Questions and Answers TNPA/2026/05/0931/5219/RFP

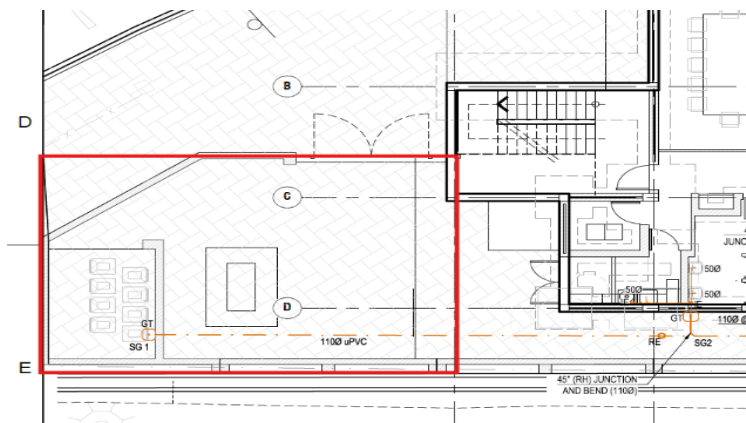
Could you please confirm if the generator area indicated below in the drawings and the extract below is indoor or open. it is not clear on the drawings.

The Genset is outdoor, on a plinth in an open, in unroofed portion of the service yard
